SUNDRY NOTICES AND REPORTS ON WELLS (DO NOT USE THIS FORM FOR PROPOSALS TO DRILL OR TO DEEPEN OR PLUG BACK TO A DIFFERENT RESERVOIR. USE "APPLICATION FOR PERMIT" (FORM C-101) FOR SUCH PROPOSALS.)		WELL API NO. 30-015-25077

2. Name of Operator COG OPERATING LLC		6. State Oil & Gas Lease No. E-742
3. Address of Operator 600 W. ILLINOIS AVE., MIDLAND, TEXAS 79701		7. Lease Name or Unit Agreement Name: NEW MEXICO EO STATE

CONDITIONS OF APPROVAL FOR PLUGGING & ABANDONMENT

Well Name & Number: New Mexico EO State #001

New Mexico _EO_ State #1 Wellbore diagram.xls

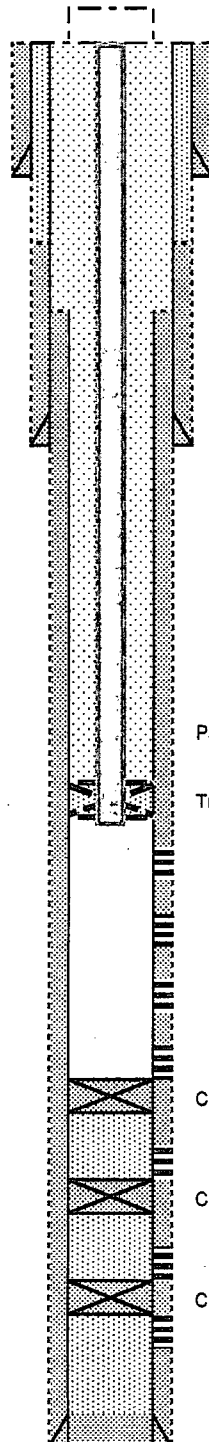
- 1) SET 5-1/2" CIBP @ 8,450'; PUMP 25 SXS.CMT. @ 8,450'-8,270'; CIRC. WELL W/ PXA FLUID.
- 2) PUMP 25 SXS.CMT. @ 7,281'-7,111' (T/WC); WOC X TAG CMT. PLUG.
- 3) PUMP 25 SXS.CMT. @ 6,005'-5,845' (T/ABO).
- 4) PUMP 25 SXS.CMT. @ 3,702'-3,572' (T/GLOR.).
- 5) PUMP 60 SXS.CMT. @ 1,355'-1,240' (B/SALT/ANY. X 5-1/2"CSG.STUB); WOC X TAG CMT. PLUG.
- 6) PERF. X ATTEMPT TO SQZ. 100 SXS.CMT. @ 505'-405' (T/SALT/ANY. X 13-3/8"CSG.SHOE); WOC X TAG CMT.PLUG.
- 7) PERF. X CIRC. TO SURF. 60 SXS.CMT. @ 63'-3'.
- 8) DIG OUT X CUT OFF WELLHEAD 3' B.G.L.; WELD ON STEEL PLATE TO CSGS. X INSTALL DRY HOLE MARKER.

7. Every attempt must be made to clean the well bore out to below the perms, before any plugs can be set, by whatever means possible.
8. **Cement Retainers may not be used.**

9. Squeeze pressures are not to exceed 500 PSI, unless approval is given by NMOCD.
10. Plugs may be combined after consulting with and getting approval from NMOCD.
11. Minimum WOC time for tag plugs will be 4 Hrs.
